East Park Energy

Outline Public Rights of Way Management Plan

Document Reference: EN010141/DR/7.8

Version **~~P03~~ P04**

Drawing Title
Outline Public Rights of Way Management Plan: Figure 1

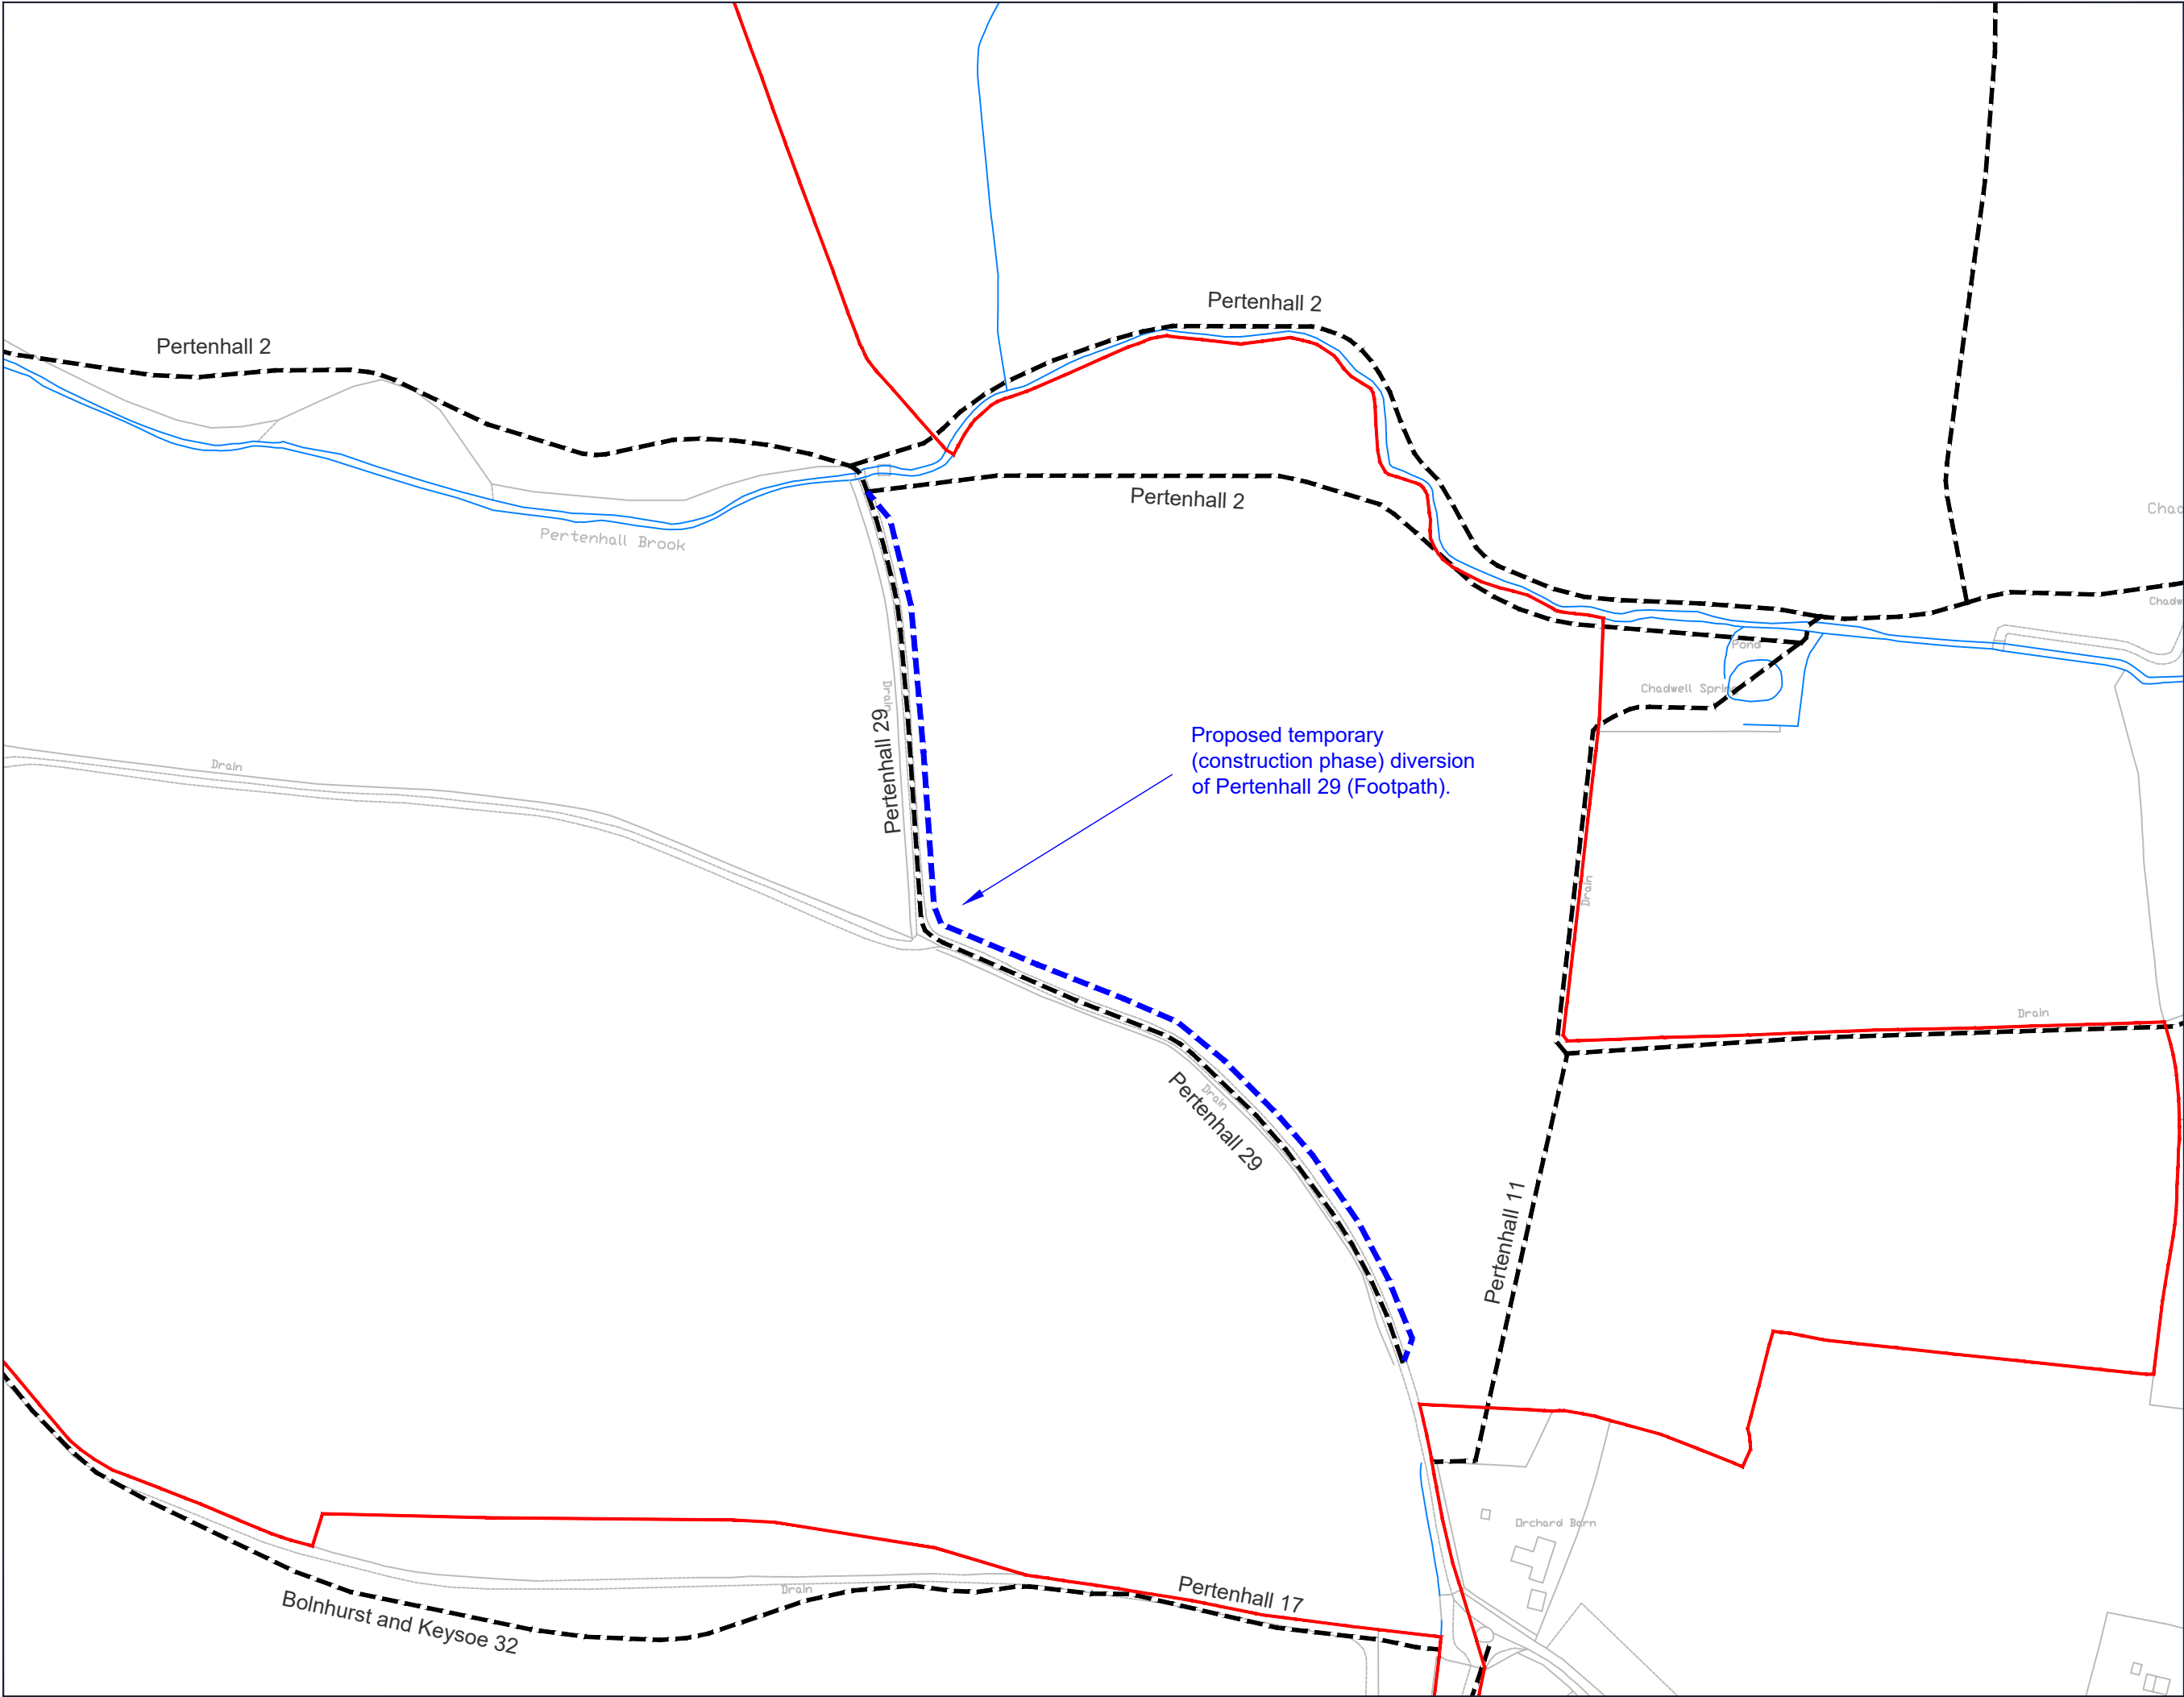
6.5.2 The route of the PRoW runs through open fields. As such, it is proposed that PRoW users ~~would~~will be protected through the provision of a temporary PRoW diversion. This ~~would~~will run through the field immediately adjacent to the existing alignment of the PRoW between Point 1 on Sheet 1 and Point 2

- on Sheets 1 and 3. Temporary fencing ~~would~~will be provided to segregate PRow users from construction traffic. The indicative alignment of the temporary diversion is shown on Figure 1 in Appendix A.

Note:
Refer to Section 6.5 of this outline Public Rights of Way Management Plan, in addition to paragraphs 5.1.4 to 5.1.8, and paragraph 5.1.14.
